SUBJECT: TECHNICAL REVIEW OF ENVIRONMENTAL MONITORING  
REPORTS FOR F-AREA AND H-AREA TANK FARM FACILITY  
FACILITIES (DOCKET NO. PROJ0734)

## Technical Review of Environmental Monitoring Reports for F-Area and H-Area Tank Farm Facilities

**Date:** December 17, 2019

**Figure 1. FTF Monitoring Well Network. Image Credit: Figure 7, SRNS-RP-2019-00097, Revision 0**

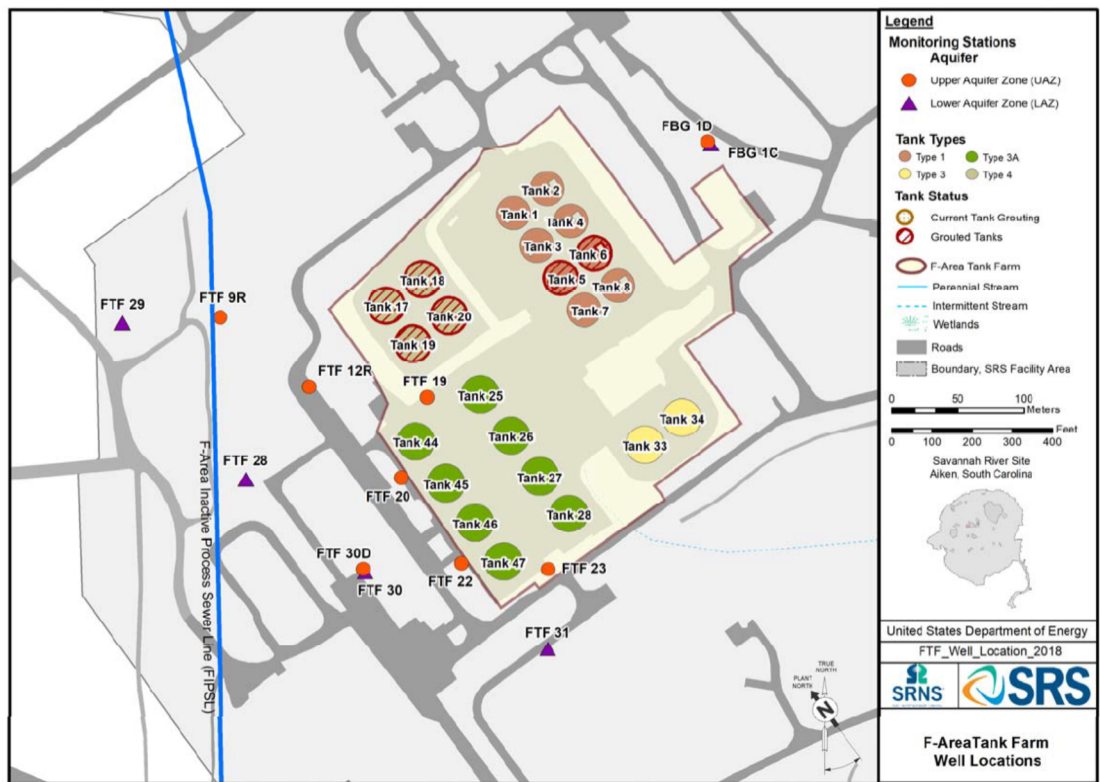
Nonetheless, to assess the potential for non-volatile beta in FTF 28 to be associated with the low pH waste release from the FIPSL, NRC staff evaluated pH data in FTF wells including FTF 28 through FTF 31 and background well FBG01C (see Figure 1). The pH data between FTF wells screened in the LAZ is variable with well FTF 29 having significantly higher pH compared to other LAZ wells and UAZ wells at FTF (see Figures 8 and 9). Because the time period of data collection from FTF 28 is longer than other wells, only paired data from the March 2014 time period and after were used in the analysis. While pH data from FTF 28 is lower than pH data from FTF 30, the average pH for well FTF 31 is actually lower than the average pH for FTF 28 (FTF 31 is not associated with the nonvolatile beta/technetium-99 plume). The pH data, which represent a log transform on hydrogen ion concentration, was considered, and the pH data was also converted to hydrogen ion concentrations. Analysis of variance (ANOVA) tests were conducted to determine if there are statistically significant differences in the means of FTF wells, excluding well FTF 29 which was significantly higher than all other LAZ wells, and t-tests were conducted to determine if the mean pH (and hydrogen ion) concentrations at FTF 28 and FTF 31 are statistically different. ANOVA testing shows that the mean pH (and hydrogen ion concentration) of the FTF wells is statistically different. The results of the analysis also show that the mean pH (and hydrogen ion concentration) from FTF 28 is statistically different than FTF 31 at the 5 percent confidence level. The cause of the variability in pH at FTF wells, including the relatively high pH at FTF 29, should be investigated further to better understand subsurface geochemistry which may affect contaminant transport at FTF. NRC staff will continue to monitor geochemical data (e.g., pH, specific conductance, carbonate concentrations) at the FTF as it relates to (i) identifying the source of contaminant plumes, (ii) potential dissolution of carbonate materials in the subsurface signified by high pH and carbonate concentrations, and (iii) to assess impacts to contaminant fate and transport at the FTF.

Tritium had previously been detected above the MCL at FTF 30D (in 2017) at a value of 105 pCi/mL (4 Bq/mL) but was less than the MCL in 2018 at a value of 1 pCi/mL (0.04 Bq/mL). Upgradient of FTF 30D, FTF 20, FTF 22, and FTF 19 were also impacted by tritium but below the MCL (see Figure 1 for locations). The concentrations at FTF 30D have been quite variable over time (see Figure 10 below). Although concentrations were stated to be low at wells upgradient of FTF 30D, no information was provided about the source of the tritium plume at FTF 30D. Further, investigation of the source of the tritium plume should be conducted using backwards particle tracking. NRC staff will continue to monitor DOE's efforts to identify the source of the tritium plume at FTF.

Figure 2. Nonvolatile Beta Results (pCi/L) Max in 2018 in the UTRA. Figure Credit: Figure 7 in ERDN-EN-2005-0127 (2019).  
Conversion: 1 pCi/L=0.037 Bq/L.

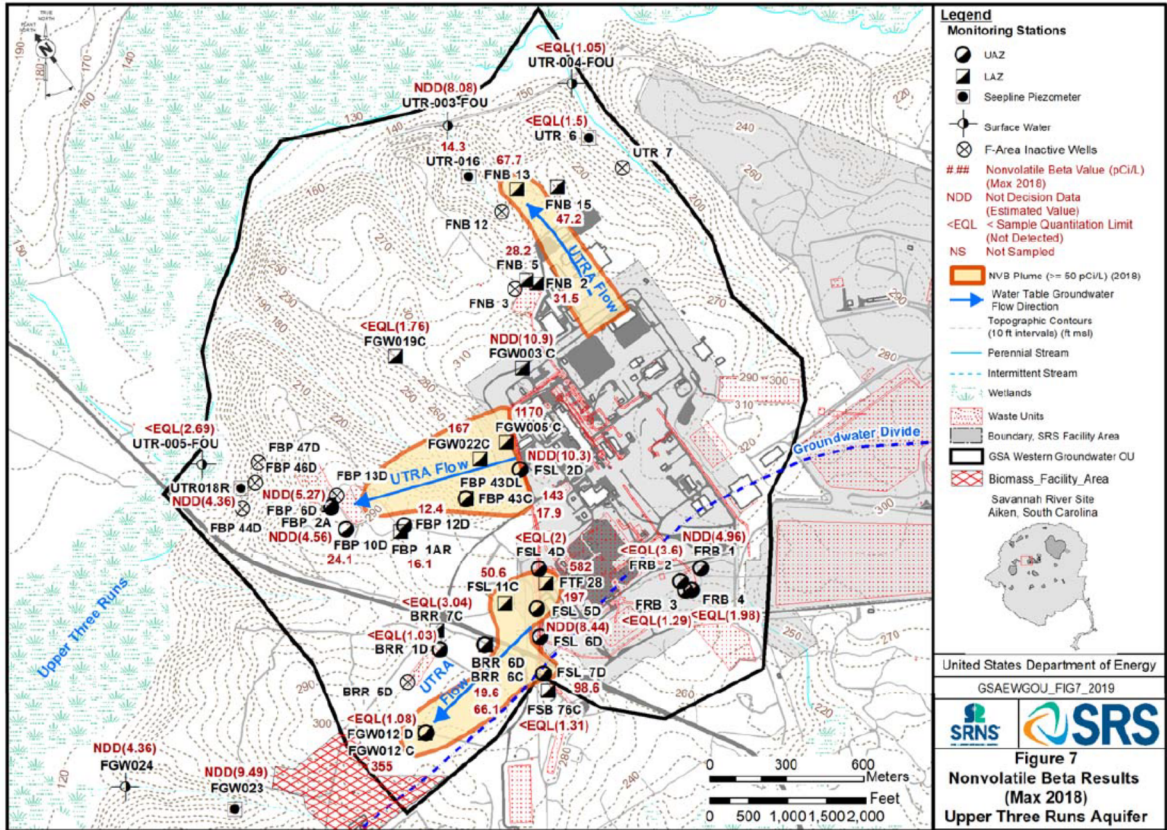
As stated above, the conceptual model for flow and contaminant transport from the FIPSL to saturated groundwater is unclear making it difficult to interpret monitoring well data from the Western Groundwater OU. For example, Figure 2 depicts data associated with the non-volatile beta plume in the Western Groundwater OU. The shape of the "southern plume" suggests the possibility of two plumes sourced from two different locations. Because FSL 6D, BRR 1D, and BRR 5D had no detectable concentration of non-volatile beta, the plume is drawn around these wells to accommodate the monitoring result leading to a jog in the plume trajectory. Similarly, Figure 3 shows tritium results for the Western Groundwater OU. Two plumes are depicted near the FIPSL collapse (and wells FTF 28, FTF 12R, and FSL 6D) and then downgradient of the FIPSL collapse (near wells FGW 012D and FGW 12C) with no contamination depicted between the two sets of wells. Furthermore, the highest concentrations are associated with the downgradient wells for the tritium plume, while the highest concentrations are associated with wells closer to the FIPSL for the non-volatile beta/technetium-99 plume. Sorption of technetium-99 in the saturated zone is minimal and therefore, transport rates for technetium-99 should be similar to transport rates for tritium. Information about travel times could also be assessed based on a review of the data for these mobile constituents, if a complete time history and coherent conceptual model for contaminant release and transport were available.

Figure 7. Forward Particle Tracking (denoted with blue arrows) from Tank 8 and FIPSL. Backward Particle Tracking (denoted with red arrows) from Wells FTF 28 and FTF 12R in Plan View (a) and Cross-Section (b).

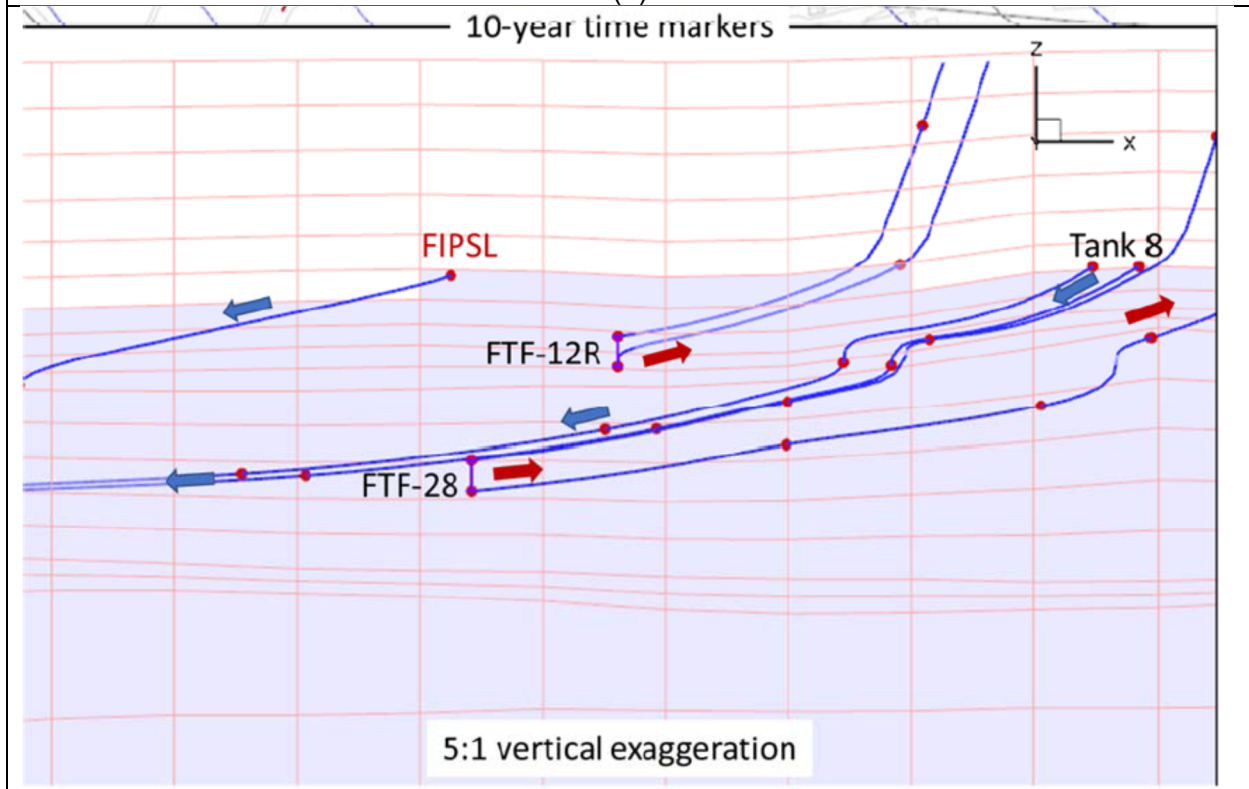
As stated in previous staff technical review reports (ADAMS Accession Nos. ML12272A124 and ML18051B154), backwards particle tracking could be informative with respect to identifying the most likely source of tank farm plumes, as well as providing useful information on the ability of the GSA PORFLOW models to detect releases from the tank farm facilities. NRC staff repeated its recommendation for DOE to conduct backwards particle tracking to evaluate the source of the technetium-99 plume at FTF 28 and FTF 12R and/or perform forward particle tracking from locations of known residual radioactivity in the vadose zone from the FIPSL collapse to support assumptions regarding the nature and extent of the technetium-99 plume (ADAMS Accession Nos. ML18311A184 and ML19143A084). Following the March 2019 OOV, DOE provided forwards particle tracking from the FIPSL and Tank 8, as well as backwards particle tracking from FTF 28 and FTF 12R. The results of the particle tracking are provided in Figure 7. Figure 7 illustrates that particle tracks released from the vicinity of the FIPSL travel through the UAZ and TCCZ for quite some distance downgradient of the FIPSL prior to transport into the LAZ and do not come close to intersecting the FTF 28 well screen located upgradient of the FIPSL and deep in the UTRA. Radioactivity from the FIPSL could have been spread laterally upgradient of the FIPSL in the vadose and traveled deeper in the aquifer than depicted in Figure 7 and dispersion could have also led to increased vertical spreading of the plume. However, it appears unlikely that radioactivity from the FIPSL could have migrated to FTF 28 through natural groundwater flow and transport based on particle tracking simulations produced from the current GSA 2018 flow model. Furthermore, Figure 7 shows that releases from Tank 8 would eventually intersect the top of the FTF 28 well screen.

Figure 11. Time Series of pH in GAU Wells at HTF

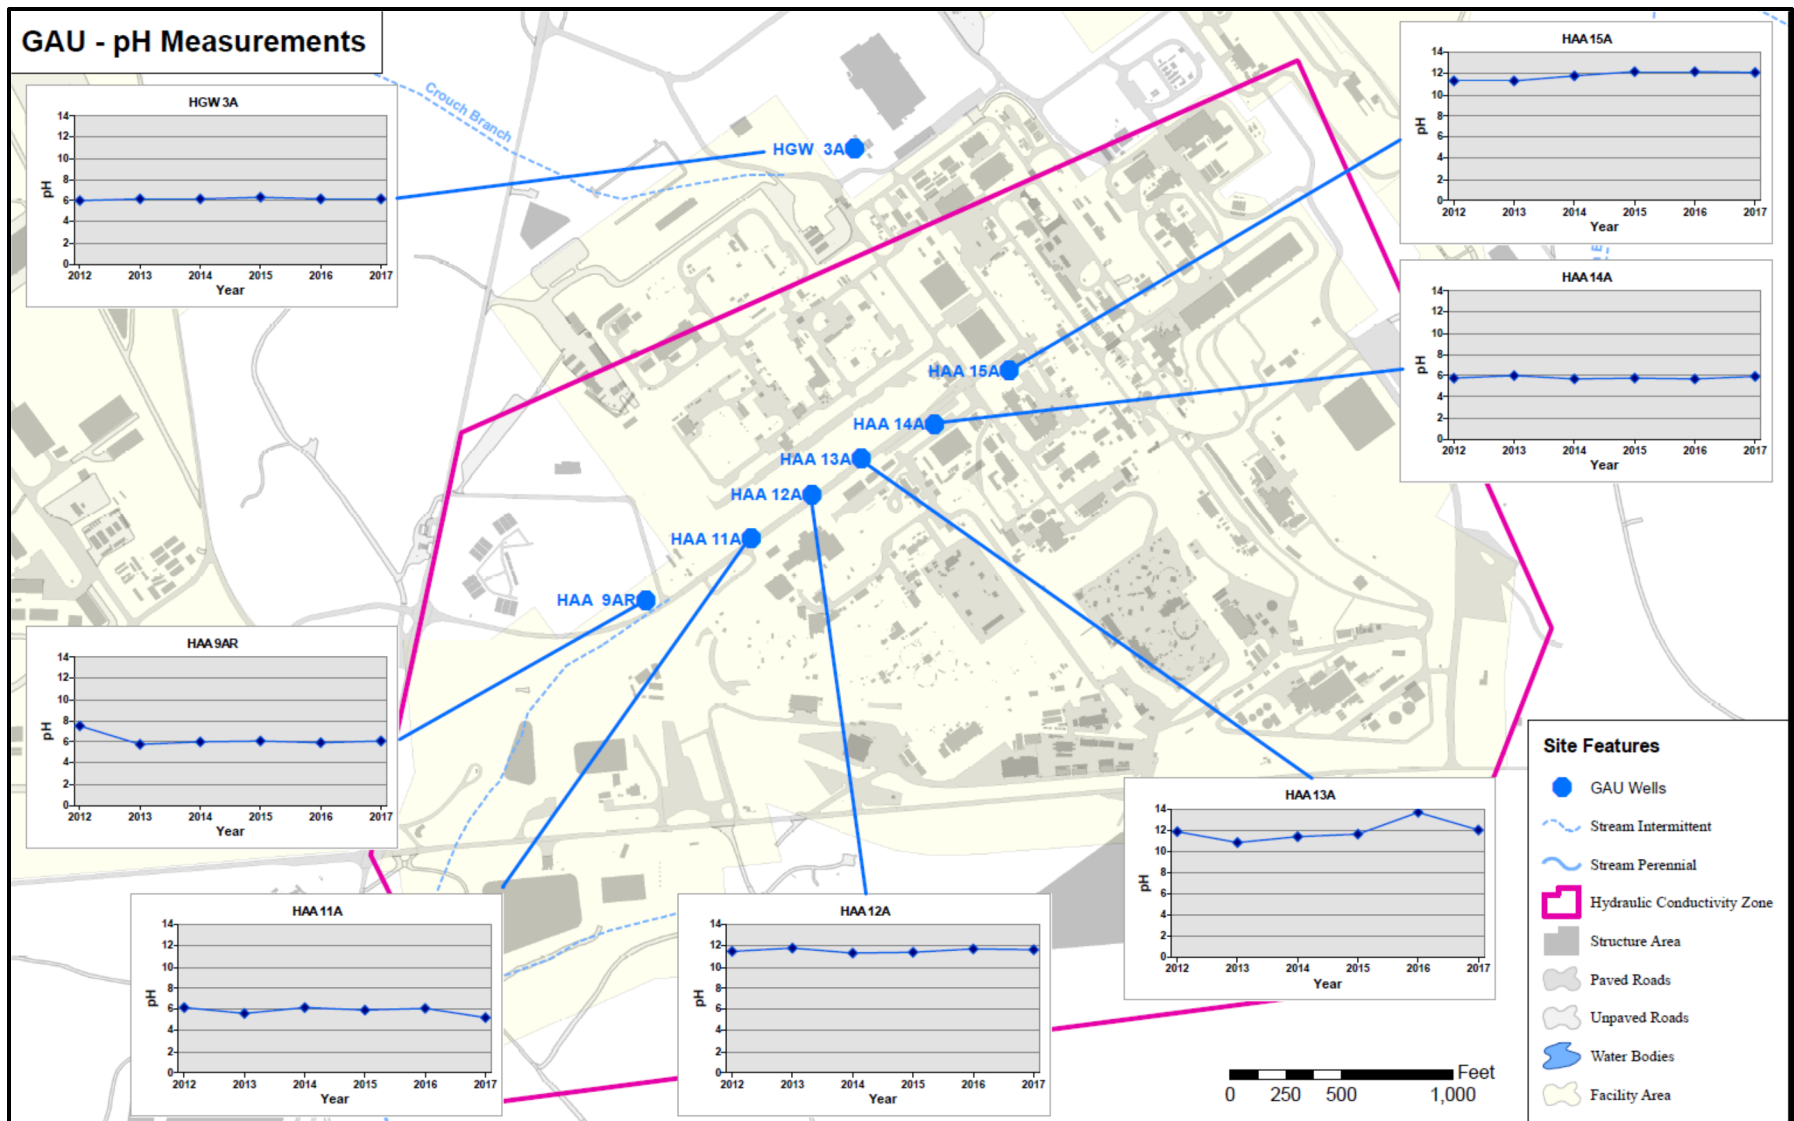
reports reviewed by NRC staff (e.g., WSRC-RP-2000-4134 [2017]), DOE contractors attributed the non-volatile beta to naturally occurring radioactivity but did not explain the source of the elevated pH in these wells. In a previous TER (ADAMS Accession No. ML18051B154), NRC staff hypothesized that the elevated pH could be an indication that the groundwater has been impacted by cementitious materials (e.g., releases from the tank farm or due to poor well construction) and suggested DOE identify the source of the elevated pH (ADAMS Accession No. ML18051B154). In fact, DOE has more recently attributed the high pH of these wells to “grout intrusion” into the well screen and plans to abandon and replace these wells in the future. The “Core Team” agreed to this resolution at meeting in September 2018. NRC staff independently evaluated data from Eastern Groundwater OU reports spanning back to 2012. While the wells were constructed in 1998, data from the 1998 to 2012 timeframe were not readily available and were not assessed. As can be seen in Figure 11, pH has been extremely elevated in these wells since at least 2012. NRC staff concurs with the decision of the “Core Team” to replace these wells and collect more representative data.
